## HYDROLOGIC ANALYSIS

Doral Crossings

Prepared for

Miami, Florida  
July 2013

Figure 3 - Northwest Wellfield Protection Area overlay (2005)

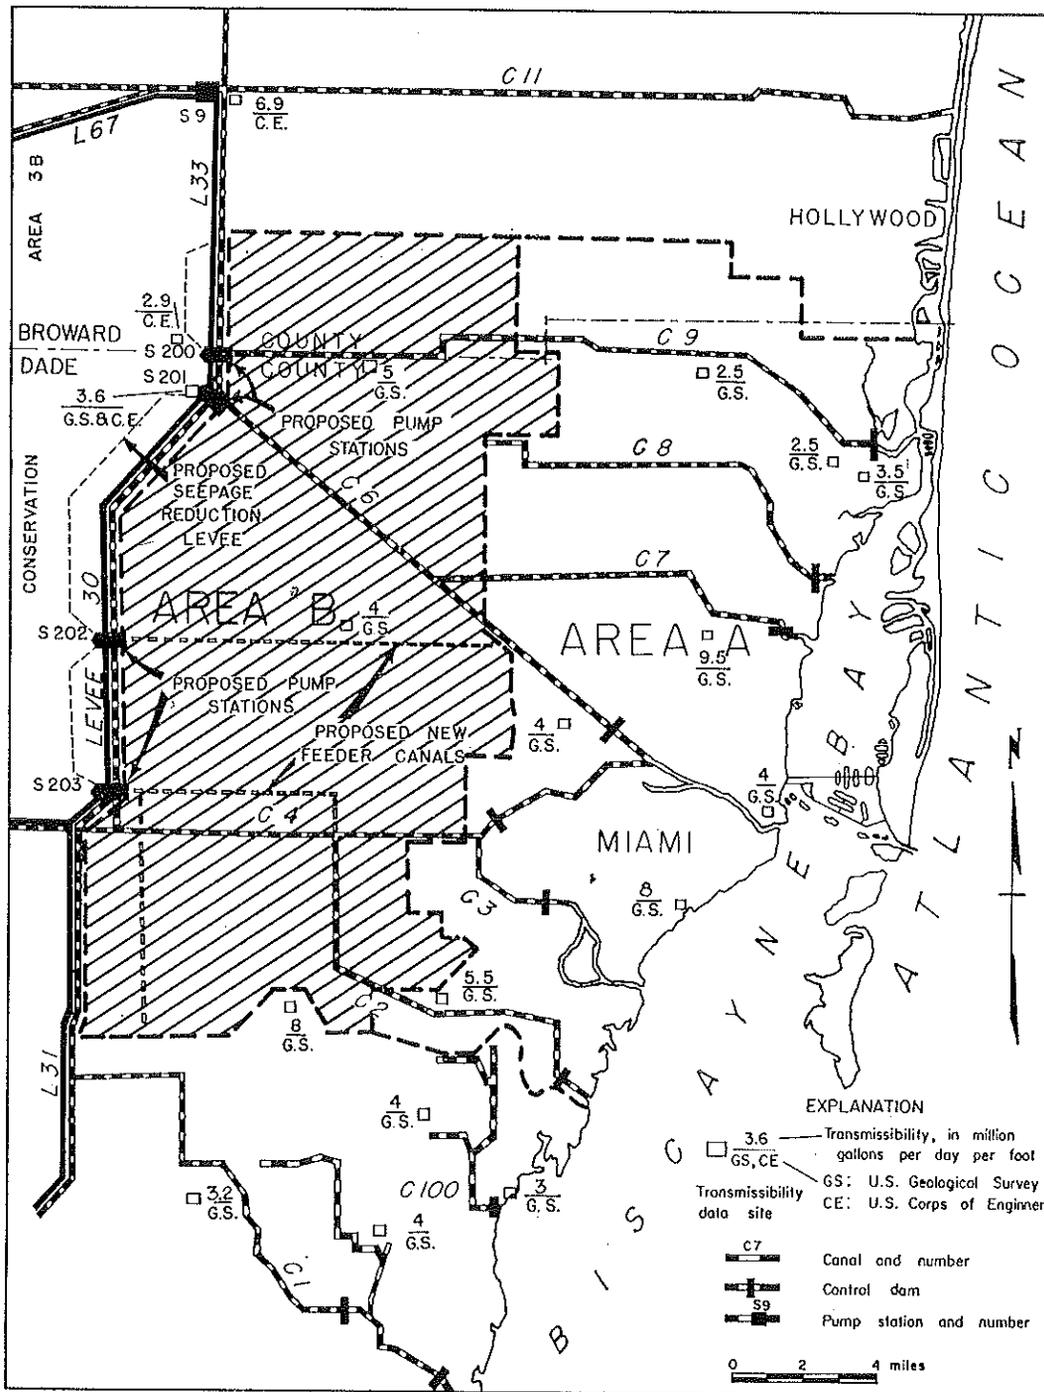
1. The Northwest Wellfield Protection Area overlay includes the Doral Crossings development site in the maximum day drawdown, but is not included in any of the travel time zones.

2. The model used to develop the protection overlay had a number of deficiencies as noted in the text above which tended to enlarge the protection area. Also, travel time boundaries and zones of drawdown were hand calculated.
